**Dairy Partners (Cymru Wales)
Limited - The Creamery,
Aberarad**

Decision Document

Refusal of a bespoke permit variation

Figure 1: Plan 1 of new ETP

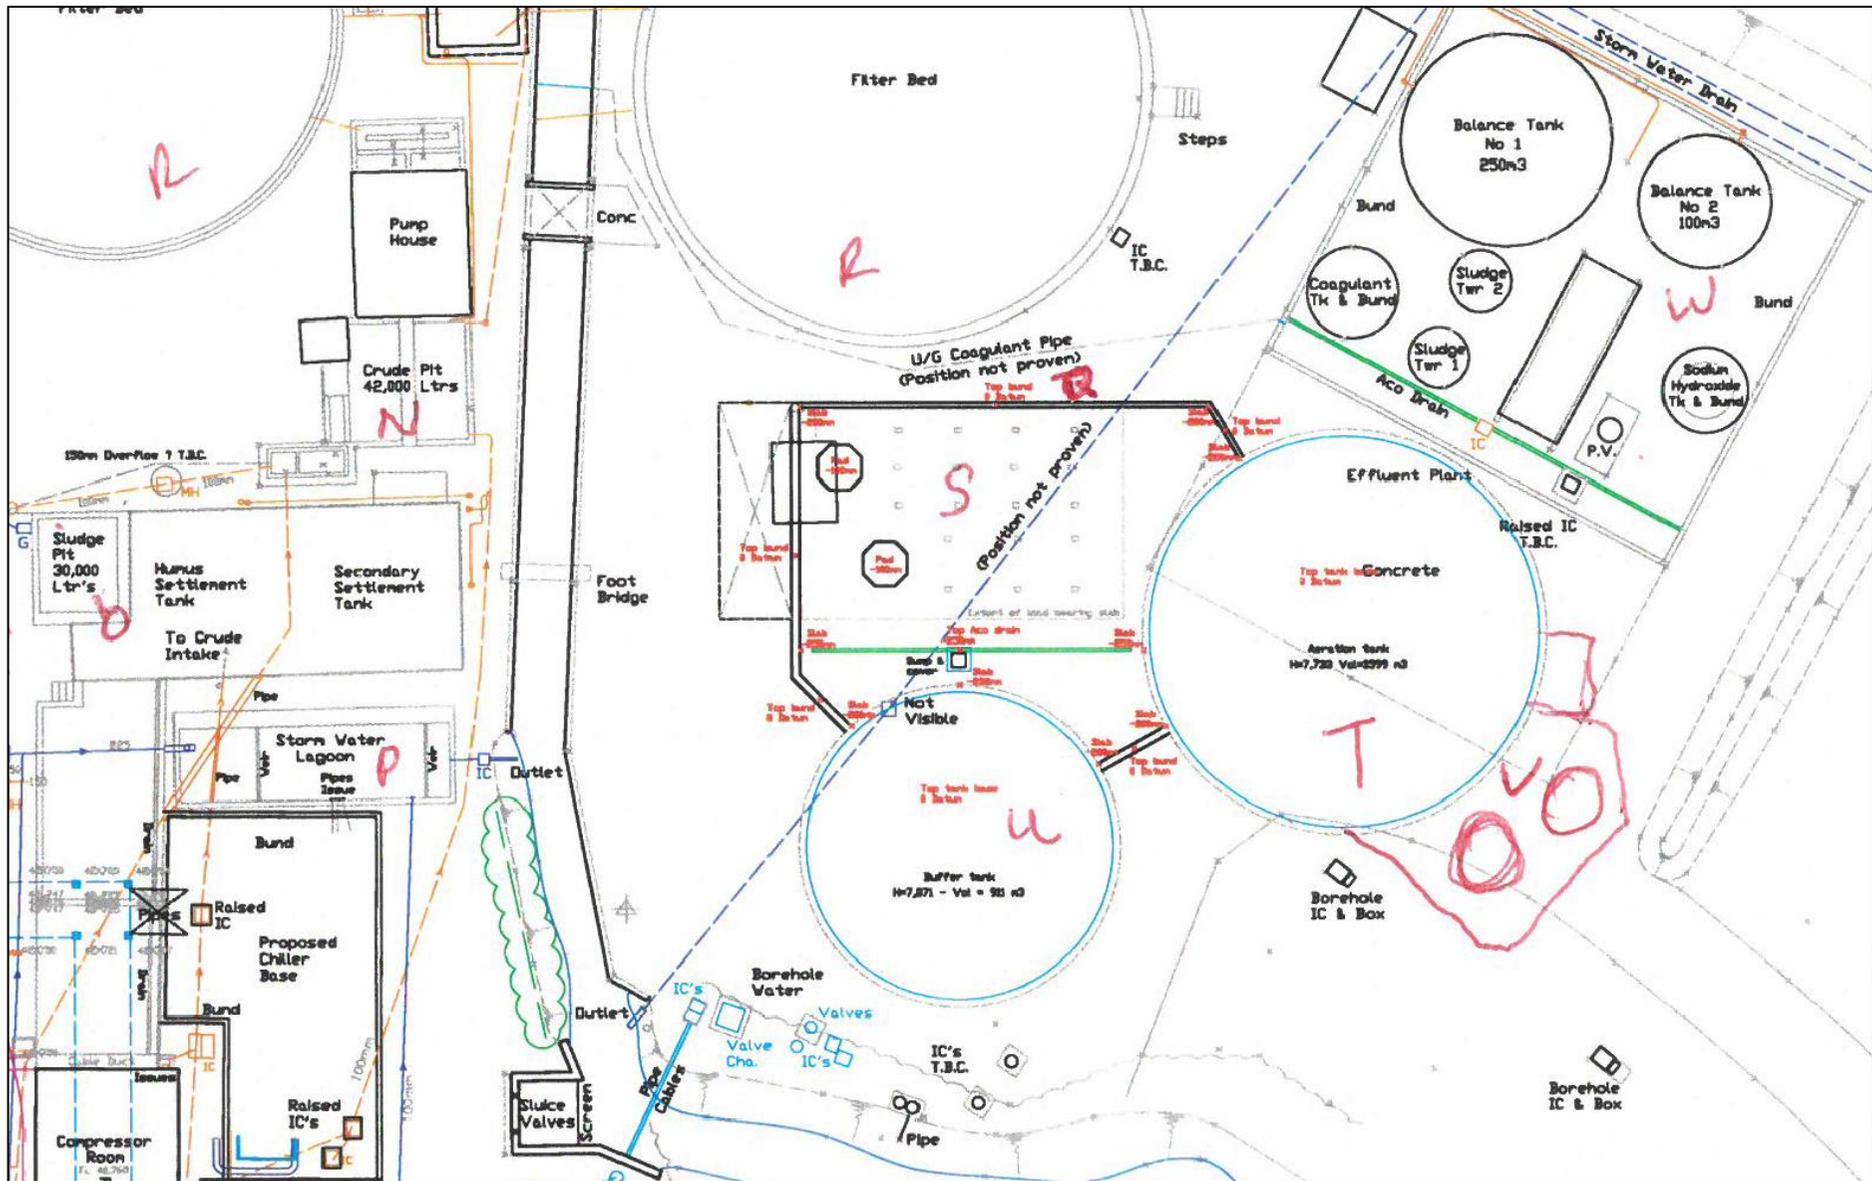
All three tanks are above-ground, 1.2 m³ (1200 L) volume double walled polypropylene tanks. They are indicated by number (4) in Figure 2 above, they are located outside of the bunded area (labelled 'S' on Figure 1) and are located on an impermeable concrete plinth. The Operator has stated these tanks are integrally bunded and has confirmed the second skin will provide containment with 110 % capacity of the primary containment. The Operator has also confirmed the second skin is structurally independent of the primary skin. The Operator has stated the tanks are refilled directly from delivery using pipework, where the chemicals are piped directly from delivery into the tanks. The Operator has stated there are 'trays' located beneath where the pipe connects to the tanks, although any capacity of trays has not been confirmed, whether

The existing bunded area marked 'W' on Figure 1 is proposed to provide secondary containment for two existing tanks that are being repurposed as the out-of-specification tanks. One is 100 m³ in volume, the other 250 m³ in volume, both tanks are numbered '10' on Figure 2. Both are above-ground, single-walled stainless-steel tanks. Both tanks are fitted with high level probes to prevent overflow. All other tanks currently situated within the bunded area and represented on the figures will be decommissioned. The surfacing of the existing bunded area is currently unknown, therefore we are unable to determine if the surfacing standards comply with those outlined in CIRIA C736. The capacity of the bund does not meet the 110 % / 25 % capacity rule as 110 % capacity of the largest tank is 275 m³, the 25 % capacity of both tanks is 87.5 m³. The Operator has confirmed the capacity of the bund is approximately 72.2 m³. The Operator has not proposed any improvements to the bund nor has provided any justification as to why the 110 % / 25 % capacity rule is not achieved. We consider improvements will be required in order to ensure the capacity of the bund is in line with what is considered BAT as outlined above. Investigations will also be required to determine the surfacing standard to ensure it is in line with standards outlined in CIRIA C736.

The new bunded area marked 'S' on Figure 1 provides secondary containment for the following tanks:

- Dissolved Air Flotation Plant (DAF 1) – above ground, stainless steel, 36.4 m³ volume tank, numbered '3' on Figure 2
- Dissolved Air Flotation Plant (DAF 2) – above ground, stainless steel, 18.3 m³ volume tank, numbered '8' on Figure 2
- Transfer tank – above ground, single-walled polypropylene, 3.1 m³ volume tank, numbered '9' on Figure 2
- Treated effluent tank - above ground, single-walled polypropylene, 3.4 m³ volume tank, numbered '5' on Figure 2

Figure 2: Plan 2 of new ETP

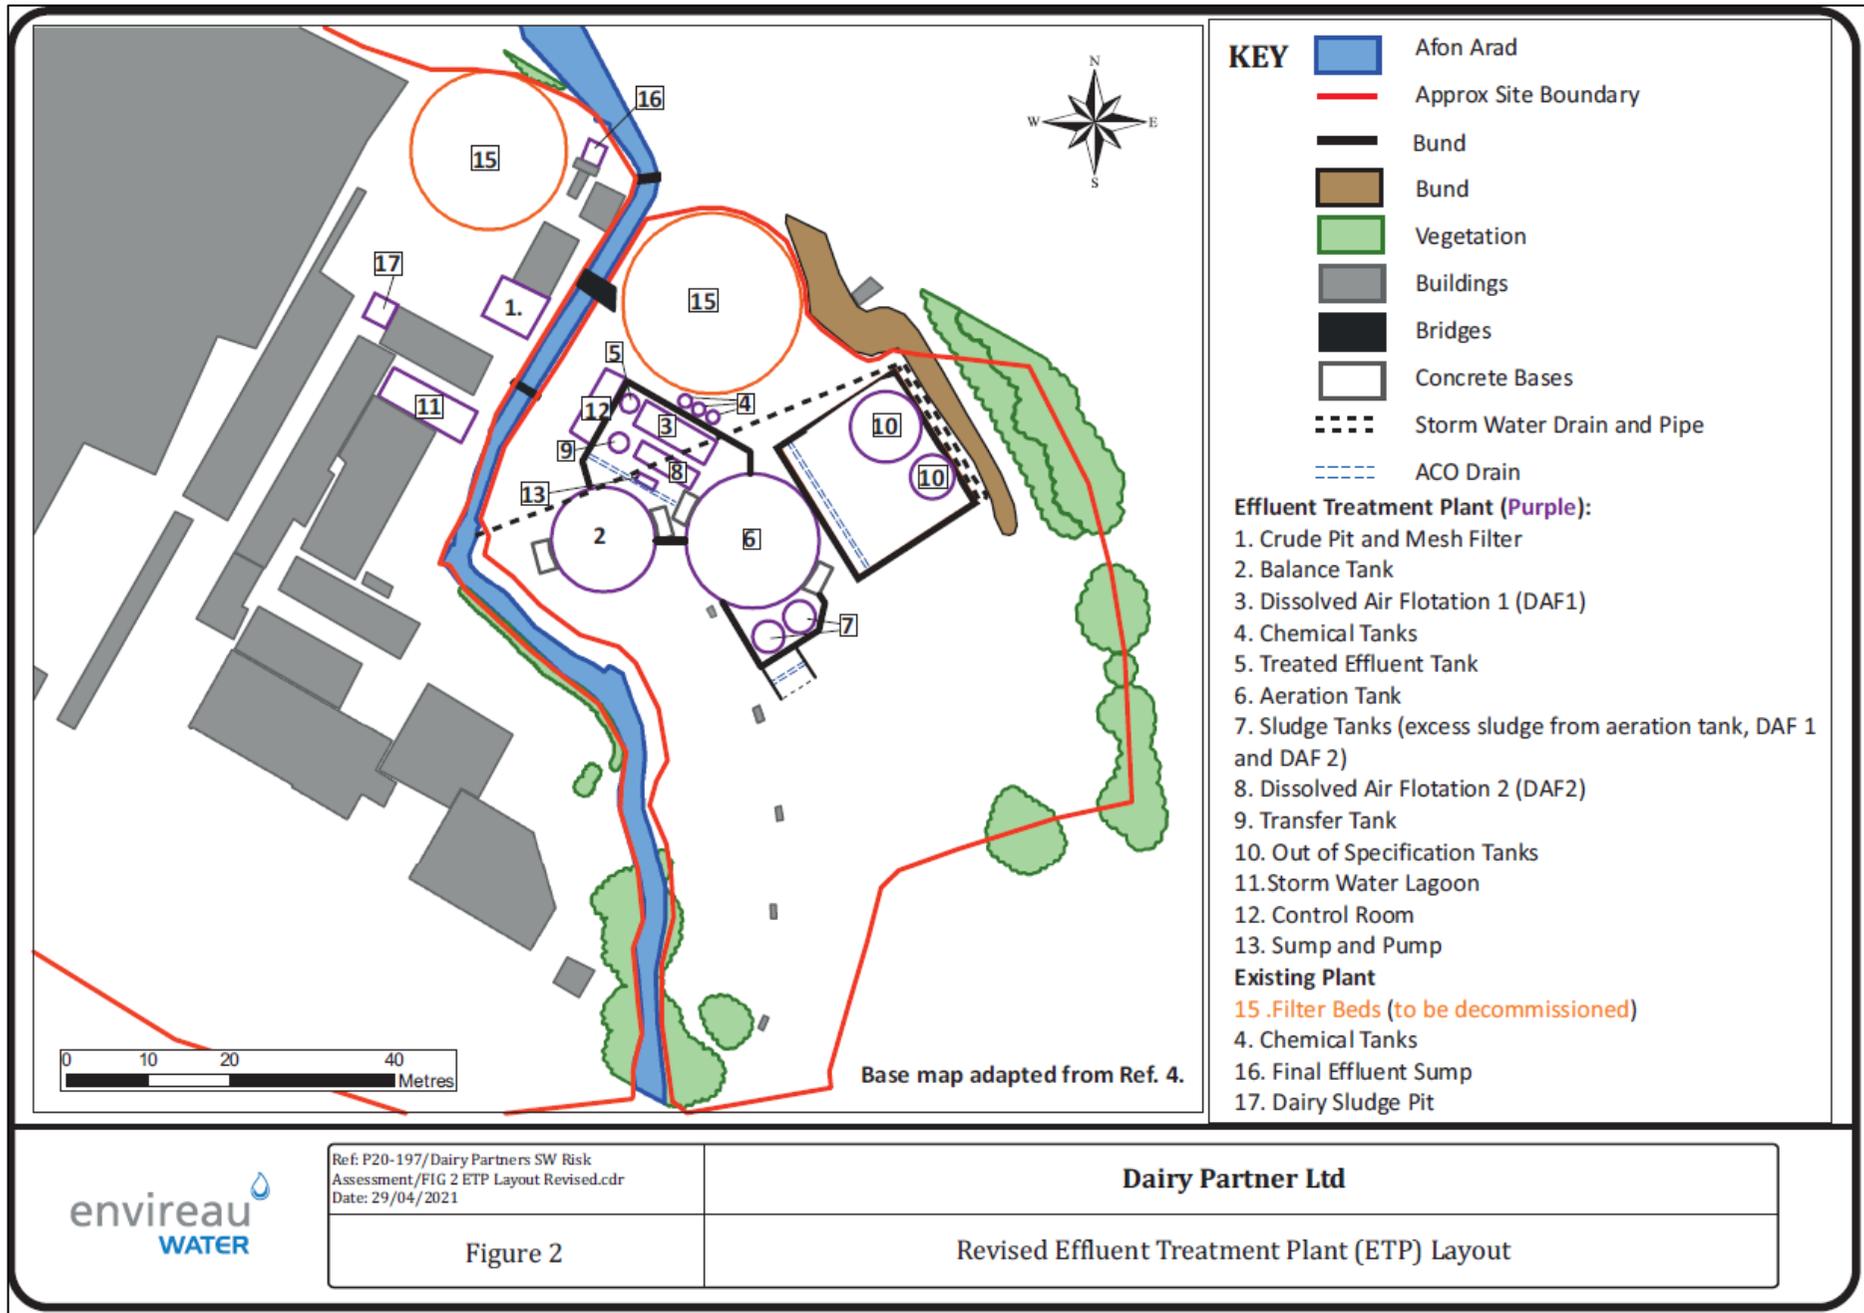
The balance tank is new infrastructure and is an above-ground, single-walled stainless-steel tank with a volume capacity of 911 m³ (911,000 L). The balance tank will be used primarily to conduct pH control as one of the first stages in the treatment process. It can also be used to either hold untreated effluent or contain spillages from drainage sumps to be rerouted through the treatment process. The balance tank is indicated by Letter 'U' on Figure 1 and Number '2' on Figure 2. The aeration tank is an open, above-ground, 1599 m³ (1,590,000 L) in volume stainless steel single-walled tank. The aeration tank is indicated by Letter 'T' on Figure 1 and Number '6' on Figure 2. The aeration tank will be where the activated sludge process takes place. The Operator has confirmed that the balance tank and the aeration tank are hydraulically linked, therefore in line with CIRIA C736 should be considered one tank for the purposes of calculating the required volume of secondary containment.

The Operator has stated that approximately 75 % of the circumference of the balance tank is unbunded and over 80 % of the circumference of the aeration tank is unbunded. The Operator has confirmed that due to the heights of both the aeration and balance tanks they are unable to provide secondary containment with at least 110 % capacity. The Operator has suggested the following proposal:

1. Providing a multi-tank bund which would bund around the aeration tank and the balance tank and at best provide 25 % capacity of both tanks. The multi-tank bund itself would not provide 25 % capacity, this would be achieved through the use of the other bunded area 'W' as indicated on Figure 1 and the out of specification tanks. The actual capacity of the proposed bund itself has not been specified by the Operator. No plans nor specifications have been provided for this proposed bund, nor any calculations to confirm 25 % capacity can be achieved. Therefore, in our view this proposal remains largely speculative.

We do not consider the current arrangement BAT as large proportions of each tank remain unbunded with no secondary containment provided. We do not consider we have sufficient information to confirm the specified capacity of the proposed arrangement would indeed be achieved. Notwithstanding this we do not consider the proposal BAT as the proposed 'at-best' capacity of the secondary containment is not adequate as outlined above in the introduction. We consider it BAT to provide

These tanks (numbered '7' in Figure 2) will store sludge produced by the activated sludge process in the aeration tank and the two DAF units. Both sludge tanks are new and above ground, polypropylene tanks, both 30 m³ (30,000 L) in volume. The area where the tanker connects to the tanks is within the new bunded area, therefore any small spills during loading or unloading would be contained within the bunded area. There is also a small slab of impermeable concrete provided outside of the bunded area for the tanker to situate on. There are contradictions in the application regarding these tanks, the Operator stated in the risk assessment that the sludge tanks are double skinned then later stated they are not double skinned. The Operator has stated they are located within a bund and therefore we assume this is proposed secondary containment and rather not a second skin as initially thought. The Operator has not specified the actual capacity of the proposed bund (labelled 'V' in Figure 1) although has stated the bund does not provide at least 110 % capacity of one tank or 25 % capacity of both tanks.

Based on the information currently available to us we do not consider the two new tanks to be provided with suitable secondary containment in line with what we consider BAT as outlined in the introduction. The Operator has not proposed any improvements to the current secondary containment measures, nor have they provided reasonable justifications that the current arrangement is BAT or why it is not practicable to provide BAT. Therefore, the variation application is further refused on that basis.

These two pits are both existing infrastructure being utilised within the new ETP facility. Both of these pits receive raw dairy effluent from the dairy processing activity. The crude pit is 42 m³ (42,000 L) in volume (numbered 1 on Figure 2) and the sludge pit is

30 m³ (30,000 L) in volume (numbered 17 on Figure 2). They are located below ground and are constructed of concrete and brick, they are located within 2 m of the Afon Arad. There is currently no secondary containment provided for either of these subsurface structures. Both are protected from flooding due to the wall being raised above the historical maximum river height. Level probes are also fitted to both of the pits to prevent overflow, the Operator has stated for both of the pits the volume of wastewater in the pits is rarely more than 50 % of total volume. There is an inspection and maintenance programme in place to prevent concrete erosion and wall damage. The Operator has not provided any justification as to why the pits are not provided with any secondary containment. Therefore, it is considered that improvements will be required to both pieces of these existing infrastructure in order to provide them with suitable secondary containment in line with what is considered BAT.

the pipe itself has secondary containment has also not been specified. The Operator has stated there is no bunding or spill kerbs provided around these tanks to contain spills during refilling or other incidents. Based on the information currently available to us we consider improvements will be required in order to provide a spill kerb around the tanks in order to contain spills. The containment of pipework is discussed below.

secondary containment with at least 110 % capacity of the largest tank or 25 % of the multi-tank volume, whichever is larger. The Operator has not proposed this standard either through current arrangements or their proposed arrangement. The Operator has not provided a reasonable justification that the current or proposed arrangements are BAT, nor have they provided a reasonable justification as to why it is not practicable to provide BAT. Therefore, the variation application is refused on the basis.
